Executive Order G-70-14-C

Relating to the Modification of the Certification of the
Red Jacket Aspirator Assist Service Station
Phase II Vapor Recovery System

Red Jacket Aspirator Assist Service Station
Phase II Vapor Recovery System

EXHIBIT 1

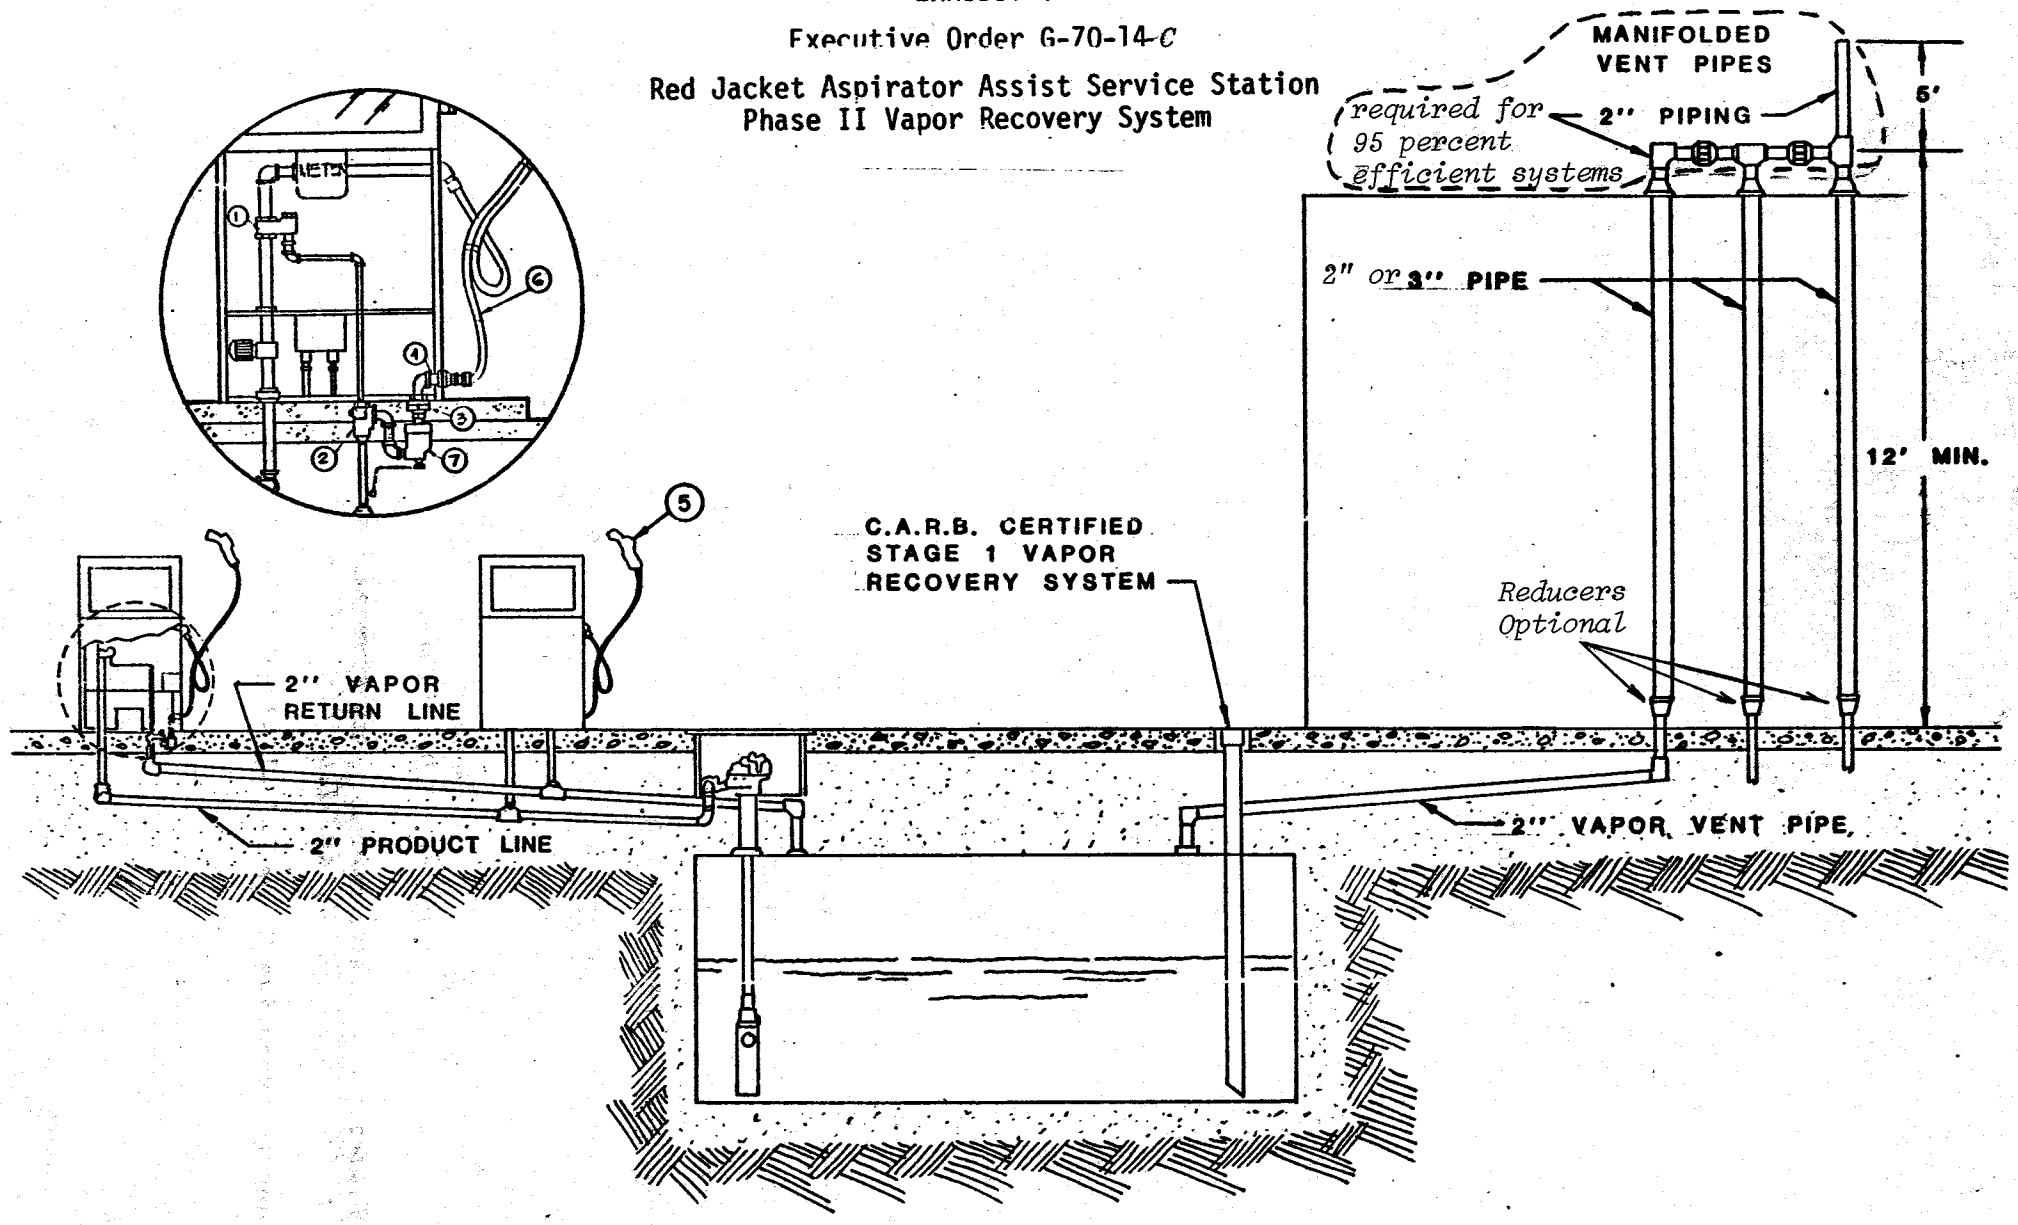
IT IS ORDERED AND RESOLVED: That the certification issued on September 27, 1978, for the Red Jacket aspirator assist, Phase II vapor collection and disposal system licensed to and marketed by Wylain, Incorporated, Red Jacket Pumps Division, is hereby modified to allow installation of manifolded 2 inch vent pipes on systems required to meet a 95 percent efficiency standard. The certification is further modified to allow installation of manifolded or non-manifolded vent pipes on systems required to meet a 90 percent efficiency standard, to allow adjusting the length of each vapor return hose according to dispenser island width, to require selection of product hose length to provide for full extension of the vapor return hose, and to require installation of State Fire Marshal approved hose swivels with minimum inside diameter of 0.495 inches to prevent kinking of vapor hoses. The system hereby modified is certified to be at least 95 percent effective with manifolded vents and at least 90 percent effective with non-manifolded vents for attendant and/or self-serve use at gasoline service stations in conjunction with Phase I vapor recovery systems which have been certified by the Air Resources Board. The system is described in Exhibits 1 and 2 attached hereto.

Note: Revisions to Executive Order G-70-14-B noted in italics

1. One-inch or larger branch lines connecting to a two-inch return pipe are required.
2. Each vapor hose shall be located such that the center line of the hose fitting, ~~at the recirculation trap~~ *at the swivel mounting at the dispenser housing,* is not more than 3-1/2 inches above the top surface of the island, and is as close to the surface of the island as possible.
3. *For dispenser islands greater than 5 feet in width, each vapor hose length shall not be longer than the sum of one-half the dispenser island width, in feet, plus 6 feet.*
4. *Product hoses one foot or more longer than the vapor hose shall be installed at each dispenser to provide for full extension of the vapor return hose.*
5. *State Fire Marshal approved swivels (and offsets if necessary) for this system shall be selected and installed on hoses to prevent hose kinking.*
